# Access Compliance Report

## Public Rights-of-Way

### (Curb Ramps)

Intersection ID: 11001	Main Street: SLAGLE_DR	Cross Street: TIPPERARY_PL	Location: W
ADA ID: C80E251D35BA	Ramp Type: ParaDiag	Initial Pass/Fail: Fail	Overall Compliance: No
			Severity Score: 26.25

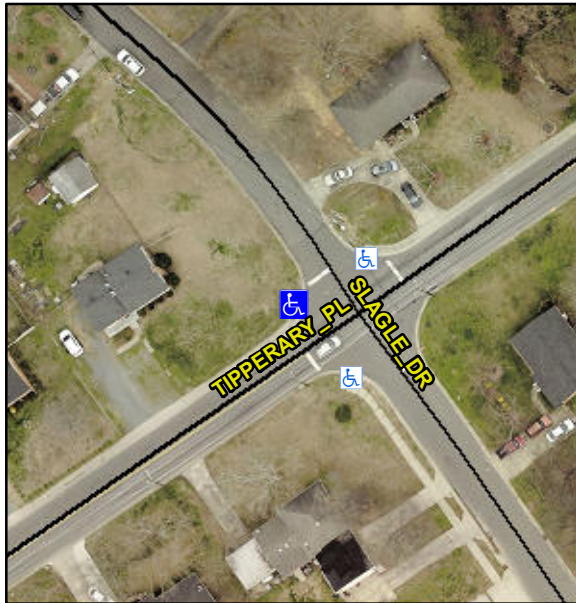
**NO RT RP, RT RP < 5%**

**R304.3.2, R304.5.3**

**Remove & Replace Curb Ramp With Two New Directional Ramps or Equivalent.**
